UNITED STATES PATENT AND TRADEMARK OFFICE

| APPLICATION NO. | FILING DATE | FIRST NAMED INVENTOR | ATTORNEY DOCKET NO. | CONFIRMATION NO. |
|---|-------------|----------------------|-----------------------|------------------|
| 10/786,307 | 02/26/2004 | Ye-Yong Kim | IK-0072 | 3458 |

Office Action Summary

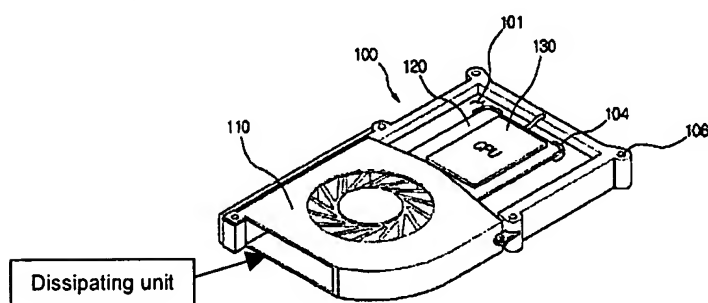
3. The disclosure is objected to because of the following informalities: The applicant seems to refer to the apparatus as "dissipating plate" ("100" in figure 2). While the applicant is entitled to be his own lexicographer, conventional art-accepted terminology is recommended. Recommend

naming the apparatus "cooling device" or some such term. Appropriate correction is required.

4. Claims 1-7 & 16-21 are rejected under 35 U.S.C. 112, second paragraph, as being indefinite for failing to particularly point out and distinctly claim the subject matter which applicant regards as the invention. With respect to these claims, it is unclear from the specification what the applicant is referring to as the "dissipating unit". The examiner has interpreted the dissipating unit as illustrated in the figure below.

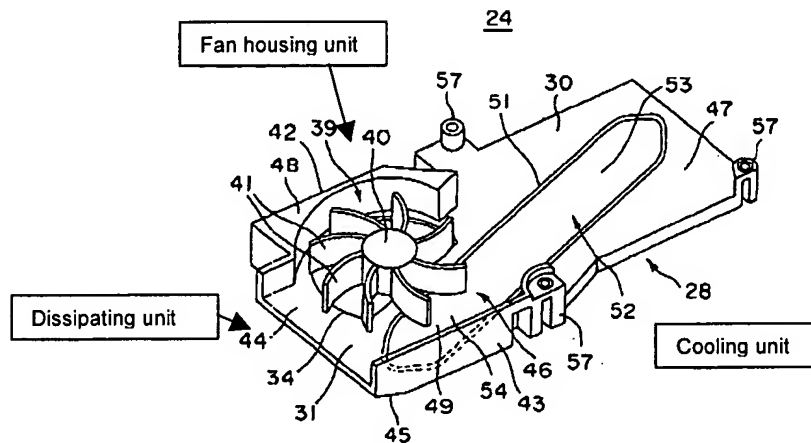
6. Claim 15 is rejected under 35 U.S.C. 112, second paragraph, as being indefinite for failing to particularly point out and distinctly claim the subject matter which applicant regards as the invention. With respect to this claim, it is unclear from the specification what the applicant is referring to as the "transfer region". The examiner has disregarded this element in the claim. Also, the specification does not identify "a plurality of guides" in the liquid cooling moving block. The examiner has interpreted the said guides to couple coolant storage block and the condensation block as mentioned in the specification.
